RUSSIAN MARITIME REGISTER OF SHIPPING

CIRCULAR LETTER

No. 313-04-1818c

amendments to the Rules for the Prevention of Pollution from Ships Intended for Operation in Sea Areas and Inland Waterways of the Russian Federation, 2022, ND No. 2-020101-163-E

Fig. 3.5.1

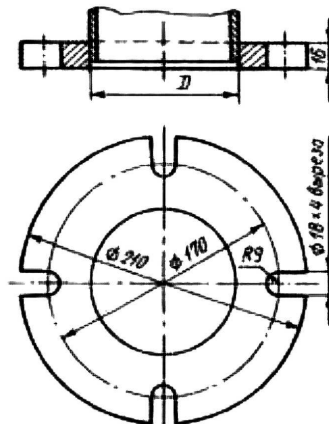
8 **Para 3.5.1.** is replaced by the following text reading as follows:

"3.5.1 In every ship, provision shall be made for a pipeline for discharge of sewage and sanitary and domestic waste waters to reception facilities.

The pipeline shall be led to both sides of the ship. The pipeline may be led out in one place, provided that sewage is possible to ensure the discharge on the both sides. The discharge manifolds shall be located in places convenient for connection of hoses and shall be fitted with standard discharge connections with flanges in compliance with Fig. 3.5.1, and also shall be provided with nameplates.

The discharge manifolds shall be provided with blank flanges.

In ships performing regular voyages, such as passenger ferries, the drain connections can be fitted with quick couplings according to the International Standard EN1306:2018.

Note. The flange is designed to accept pipes up to a maximum inner diameter of 100 mm and shall be of steel or other equivalent material having a flat face. This flange, together with a suitable gasket, shall be suitable for a working pressure of 0,6 MPa. For ships having a moulded depth of 5 m and less, the inner diameter of the discharge connection may be 38 mm. The flange is connected by four bolts of suitable length and of 16 mm in diameter each."
